Exhibit 2 Item 7-D, March 9, 2020 Planning Board Meeting

ALAMEDA MARINA TOWNHOMES
ALAMEDA, CA # 2014-0798.01

DESIGN REVIEW NOVEMBER 25, 2019

SITE PLAN & PROJECT DATA
ARCHITECTURAL COLOR & STYLISTIC VARIATION

A1.0.0

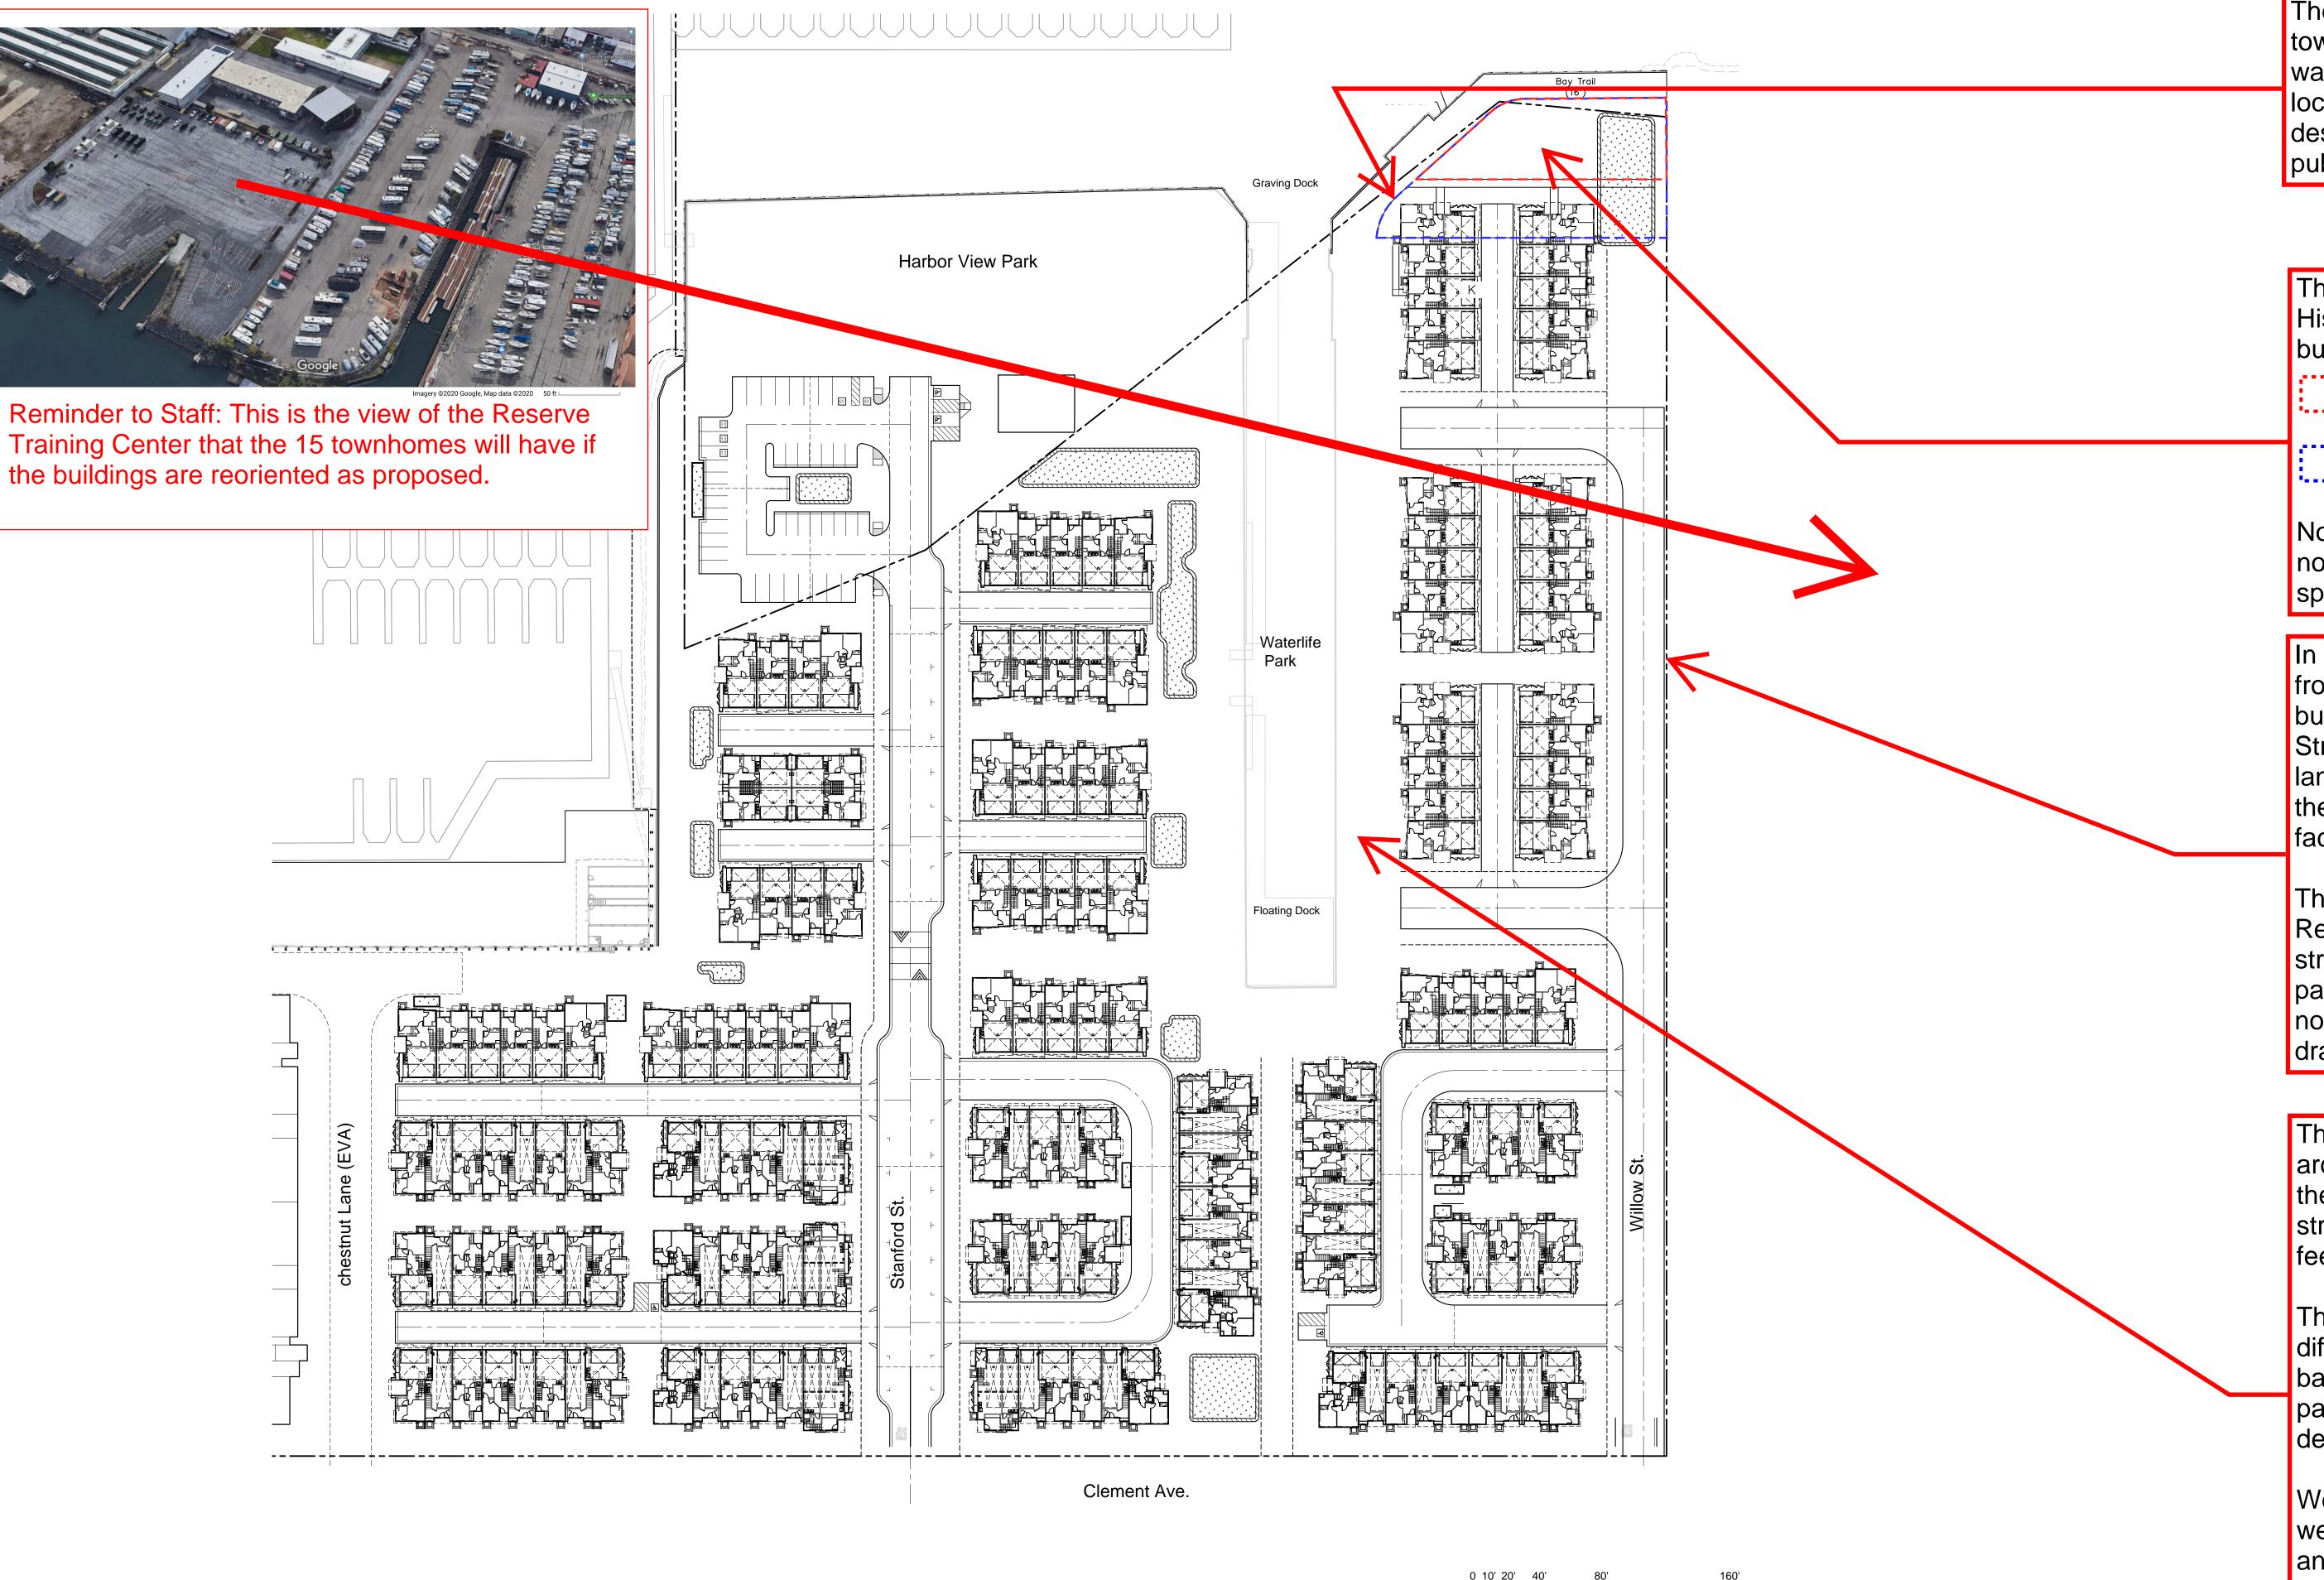
The landscape buffer between the townhomes and the publicly accessible waterfront is reduced greatly at this location. This runs counter to the BCDC desire for clear delineation between public and private open space.

The revision to the Native American Historical Memorial due to the revised building layout reduces its size by 1/2

Revised Memorial: 6,557 sq.ft.

Previous Memorial: 12,960 sq.ft.

Note: the area calculations provided do not account for any loss of usable open space due to C3 requirements

In order to maintain the necessary street frontage between the reoriented buildings and the extension of Willow Street, there is NO room for any landscape buffer between the street and the adjacent parking lot for the Navy facility.

This means that the 15 units facing the Reserve Training Center along this stretch will be looking directly at the parking lot and barbed wire fencing with no chance of a landscape buffer, drastically reducing their value.

The previous layout had a consistent architectural treatment on both sides of the Waterlife Park, giving the park a strong and consistent character and feel.

The revised layout creates drastically different character on the opposing banks of the park, giving one an open, parklike feel and the other a more dense, urban feel.

We feel that the revision significantly weakens the look and feel of the park and gets away from the Planning Board's desire for a strong hierarchy to the architecture facing the Waterlife Park.
